Reference: 55 Beardwood Blackburn.

Planning Application No: 10-17-1173
Address: 55 Beardwood Brow, Blackburn

<u>Description: Change of use from dwelling to local prayer facility</u>

Predetermination – Noise Impact

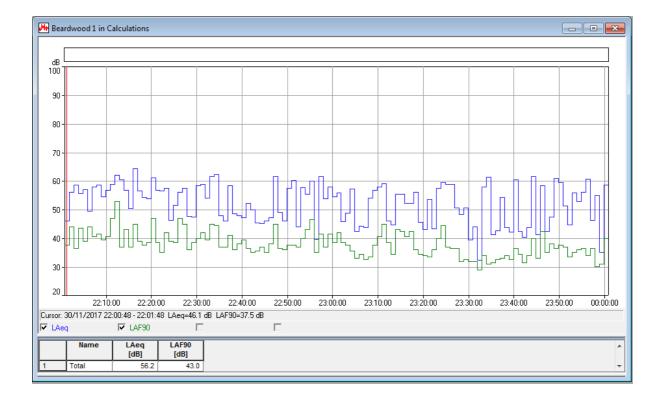
As can be seen from the Table reproduced from the original report the levels at Location 2 were measured at :

Location / Time	LA eq	LA 90
2 / 21.00 – 21.20	51.2	37.7
1 / 21.50 – 22.10	58.1	40.9

Location / Time	LA eq	LA 90
2 / 06.55 – 07.15	41.7	36.6
1 / 07.20 – 07.40	47.2	38.2

Whilst it is still unlikely that all the parking bays will be used during the early morning / late evening prayers it can be seen that the calculated level - if they were - of 57 dBA exceeds the existing measured noise level (it is likely that the actual noise level at this location will fall further between the hours 05.00 and 07.00).

We would therefore recommend that at both early and late prayer times only the 'front' car park is used and the use of the car park adjacent to Balmoral is prohibited.

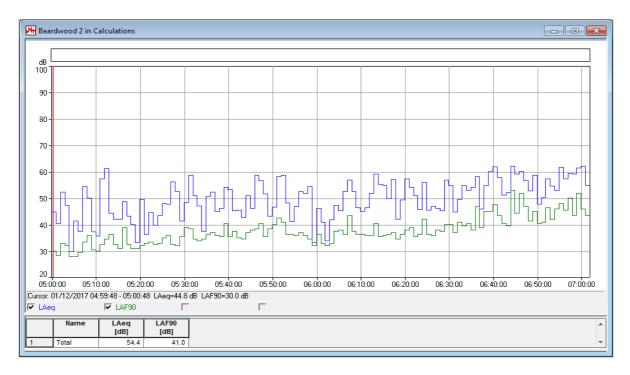
As can be seen the measured LA eq between 22.00 and 00.00 was 56.2 dBA (T = 1 minute) - the peaks on the graph representing the passage of car / cars passed the measurement location.

The level generated by an actual car passage being of the order of $55 / 57 \, dBA$ – it is also shown that there is a reasonable level of traffic movement up to $00.00 \, hrs.$

As can be seen the measured LA eq between 05.00 and 07.00 was 54.4 dBA (T = 1 minute) - the peaks on the graph representing the passage of car / cars passed the measurement location.

The level generated by an actual car passage being of the order of 55 / 57 dBA – it is also shown that there is a reasonable level of traffic movement between 05.00 - 06.00 and 06.00 - 07.00 hrs.

From the above the calculated noise level of the use of the 'front' car park is calculated to be between 41 / 48 dBA which is below the existing measured level.

However the use of the 'front' car park – again to its maximum capacity - generates levels below the measured existing noise levels at that location and therefore its use should not cause disturbance to the occupiers of the two adjoining properties.
